IEEE 802.16 Broadband Wireless Access Working Group <<http://ieee802.org/16>>

Title **Comments on location information request and response messages**

Re: IEEE 802.16j-07/013: "Call for Technical Comments Regarding IEEE Project 802.16j"

The purpose of this document is to comment subclause 6.3.2.3.65 location information request and response messages. In order to facilitate the incorporation of this proposal into IEEE 802.16j standard, specific changes to the baseline working document IEEE 802.16j-06/026r3 are listed below.

Figure uuu Relay location information request procedure – MR-BS

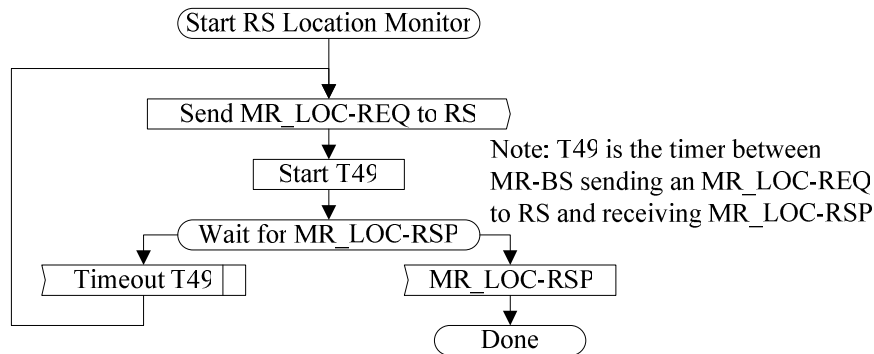
The flow charts (Figure uuu, and Figure vvv) on the following pages defines MR_LOC-REQ process that shall be followed by compliant RSs and MR-BSs.

Figure yyy Relay location information response procedure – RS

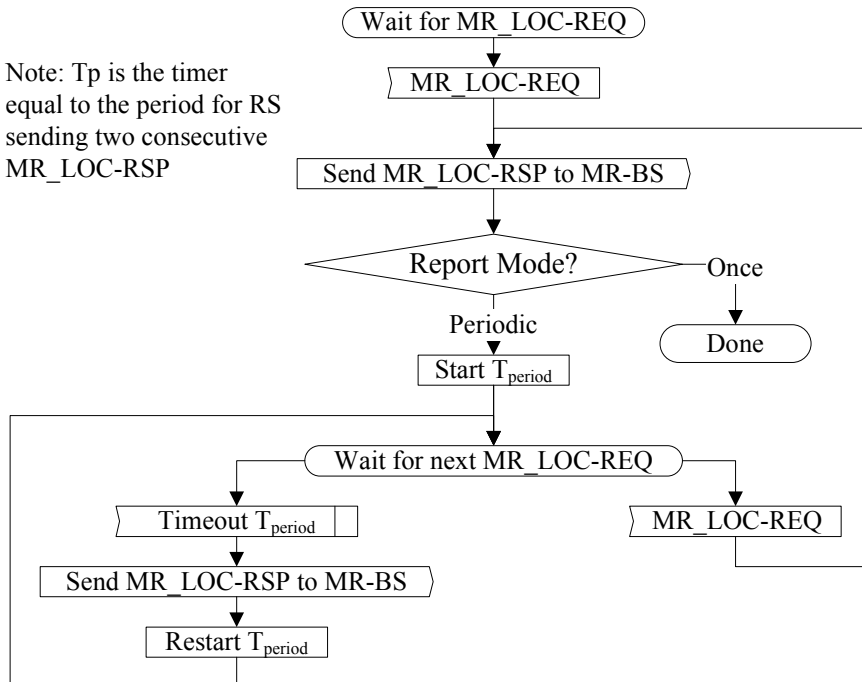
The flow charts (Figure xxx, and Figure yyy) on the following pages defines MR_LOC-RSP process that shall be followed by compliant RSs and MR-BSs.
